March 13, 2025

**Re: Applicant: AutoZone Inc.
Owner: NNN REIT, LP
Site Plan Waiver and Bulk Variance Request
Block 3, Lot 2.01-775 Route 70 West
Township of Evesham, Burlington, New Jersey
Evesham ID P25-01
TDG Project No. 2019-109.59P-Planning Letter #1**

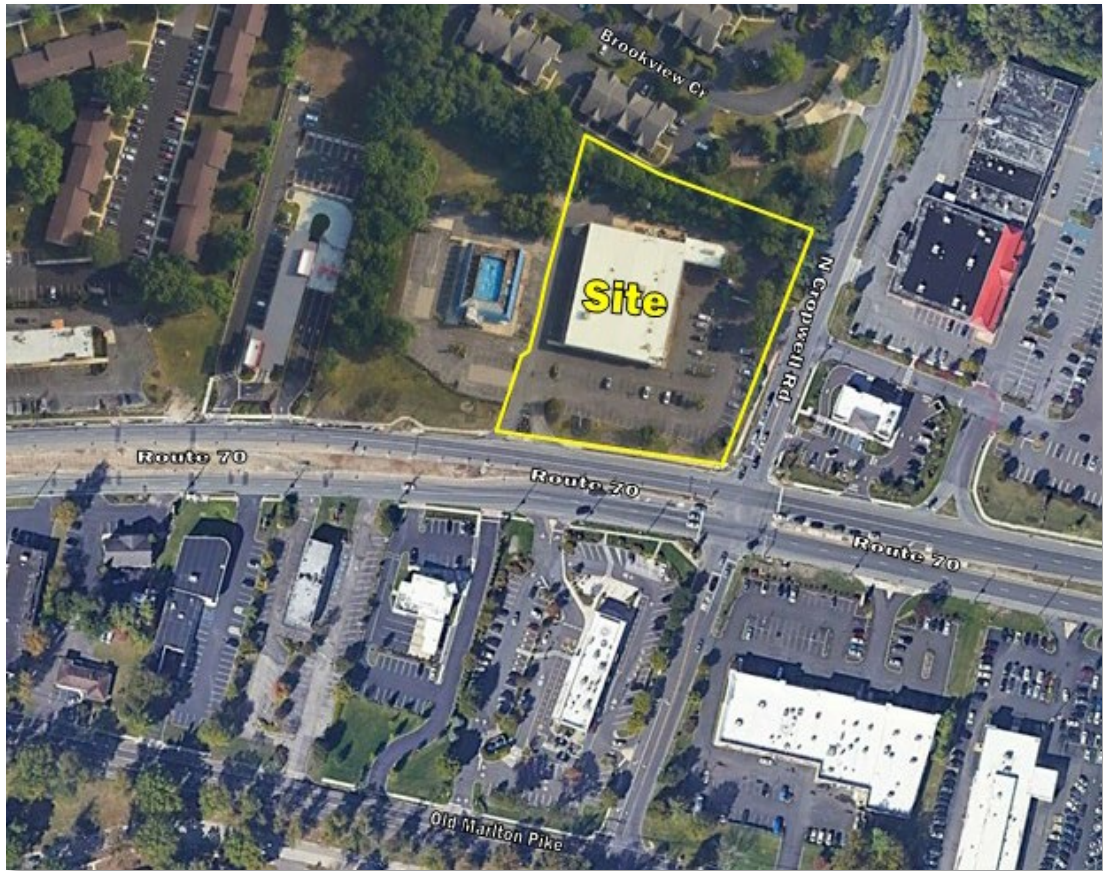
5. The plans note that sign permits will be sought by others, but variances from the sign ordinance appear necessary and should be sought as part of the application.
6. The site and surrounding area can be seen in the image below, courtesy of Google EarthPro©2025.
